Intermittent MIL "ON" DTC P0335

Service Category Vehicle Interior

Some 2006 – 2012 model year vehicles equipped with the 2AZ engine may exhibit an intermittent MIL "ON" condition with Diagnostic Trouble Code (DTC) P0335 (Crankshaft Position Sensor "A" Circuit) stored. The intake camshaft gear assembly has been improved to help prevent this condition.

Figure 1.

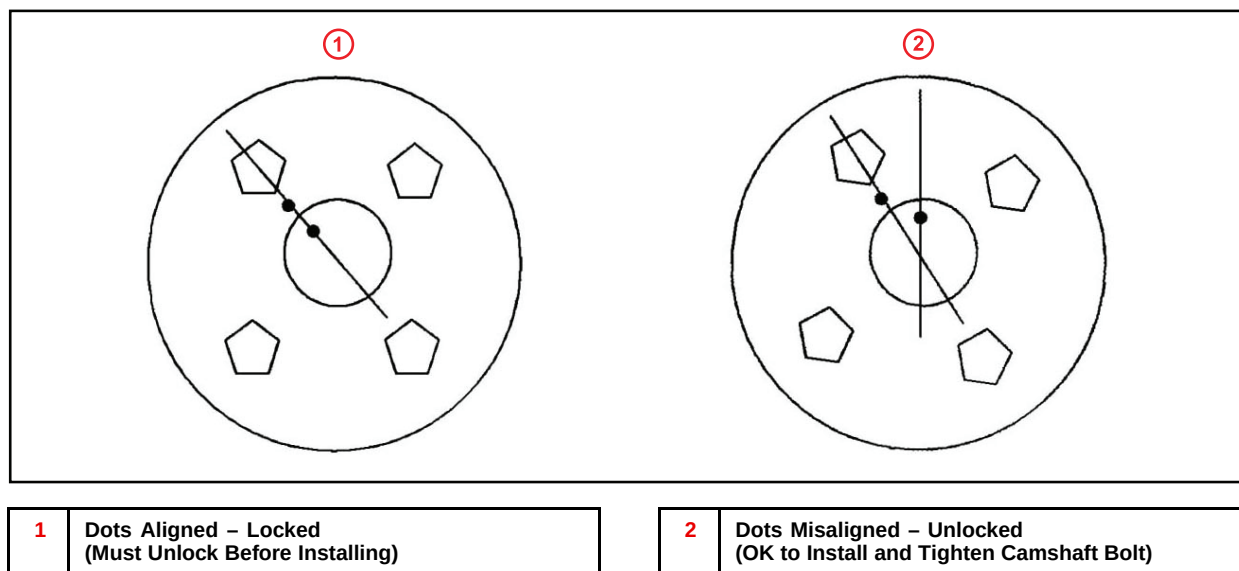
3. Identify whether the camshaft timing gear is unlocked or locked. (See Figure 1).

- If the camshaft timing gear is unlocked, it is ready to install.
- If it is LOCKED, follow the steps below to unlock the camshaft timing gear **before** installing.

Figure 2.

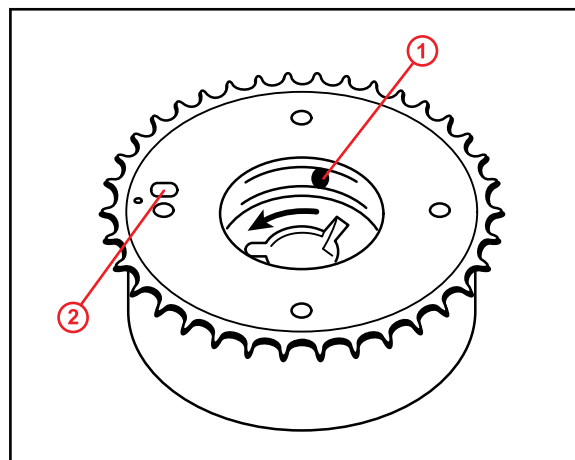
- A. To disengage the camshaft timing gear lock pin, apply and hold approximately 21 psi of air pressure at the oil feed hole located 90 degrees clockwise of the oval slot. (See Figure 2.)

The lock pin is inside the gear, NOT the one located in the oval slot.

- B. With the 21 psi of air still applied to the gear, turn the interior assembly counterclockwise. (See black arrow in Figure 2.)
- C. Install the timing gear assembly onto the camshaft with the straight pin slightly to the right of the key groove as shown in Figure 3.

Figure 4.

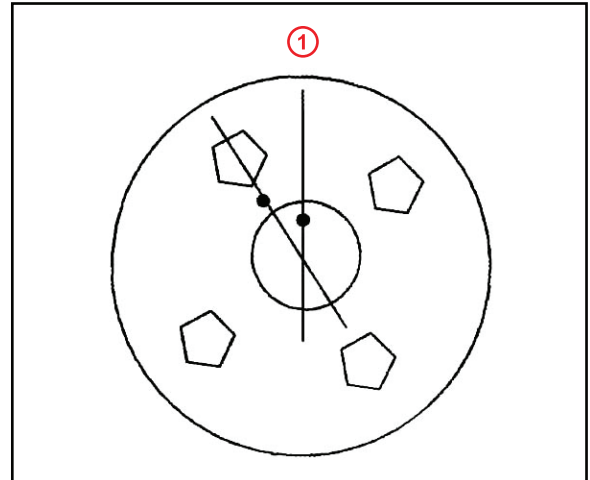
Check to make sure that the camshaft timing gear is still unlocked **BEFORE** tightening the camshaft bolt. The lock pin **MUST** be unlocked to prevent damage to the camshaft timing gear lock pin during tightening.

Dots Misaligned – Unlocked
(OK to Install and Tighten Camshaft Bolt)

Figure 5.

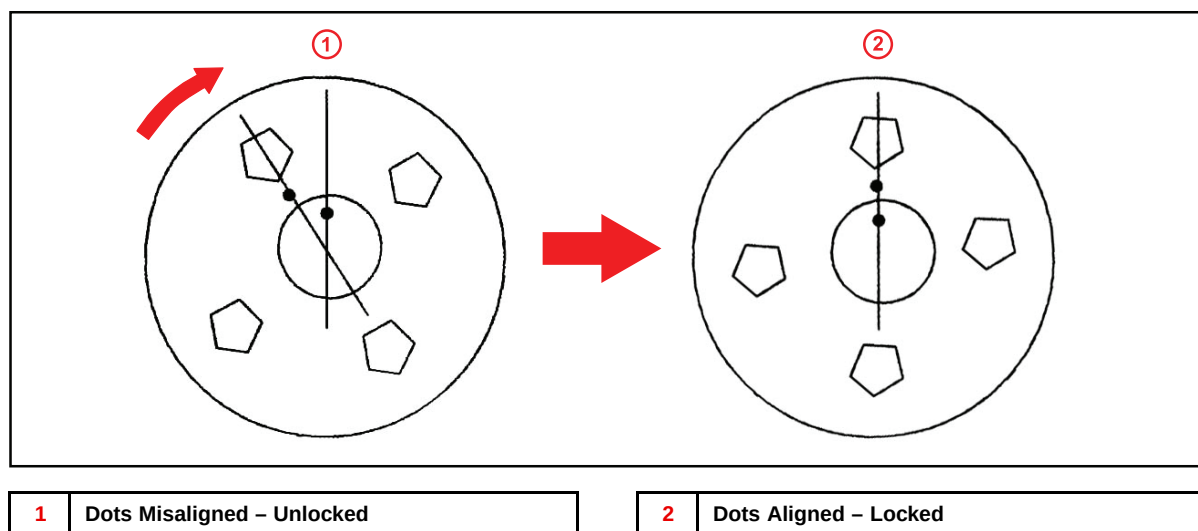
- G. After torquing the camshaft bolt, rotate the camshaft timing gear clockwise while holding the camshaft stationary until the dots are aligned, to engage the camshaft timing gear lock pin.

Camshaft timing is performed with the camshaft timing gear in the locked position (dots aligned).
